DCN No. E990327-00-D

DOCUMENT CHANGE NOTICE (DCN)

DOCUMENT No. (DOC-REV-GP. ID)	TITLE	NEW REV.
D990197-00	BEAM DUMP, FLEX SUPPORT, ASSEMBLY	A

DESCRIPTION: BEAM DUMP FLEX SUPPORT ASSEMBLY

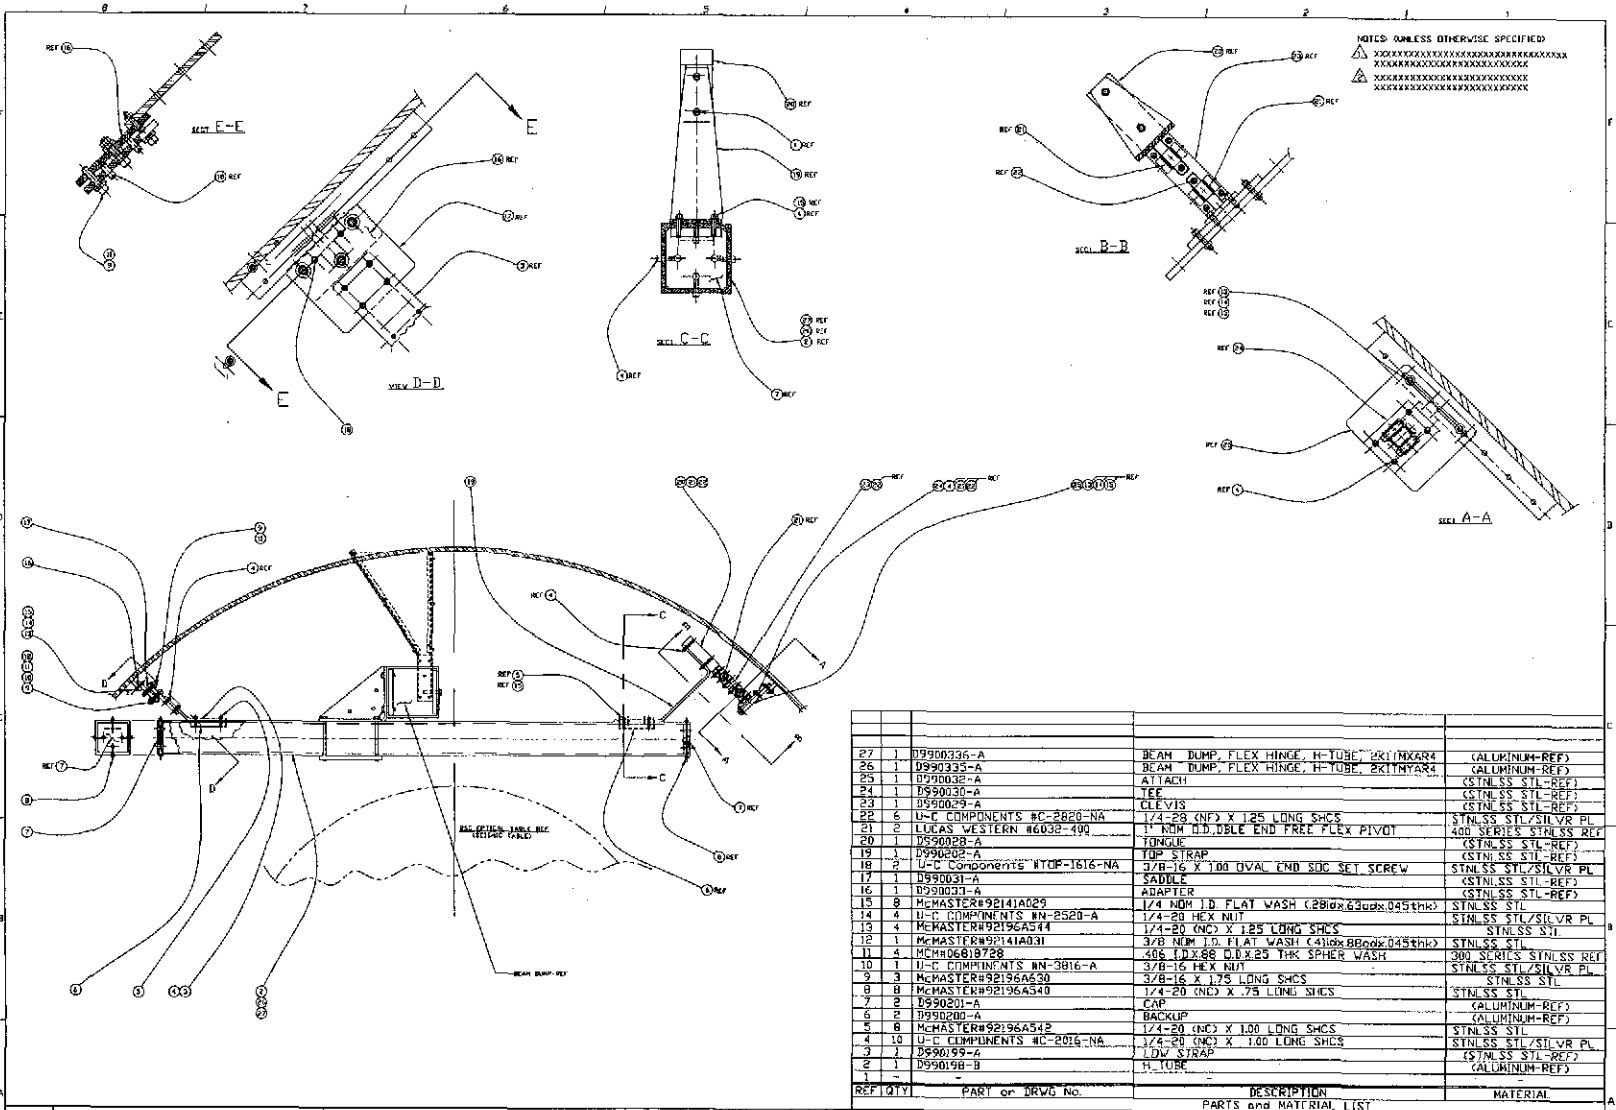
TO CHANGE: FUNCTIONAL & 1/8" ANGLE & 1/4" ANGLE (A3 & A4) & 3/8" ANGLE (A5 & A6) & 1/2" ANGLE (A7 & A8) & 3/4" ANGLE (A9 & A10) & 1" ANGLE (A11 & A12) & 1 1/4" ANGLE (A13 & A14) & 1 1/2" ANGLE (A15 & A16) & 1 3/4" ANGLE (A17 & A18) & 2" ANGLE (A19 & A20)
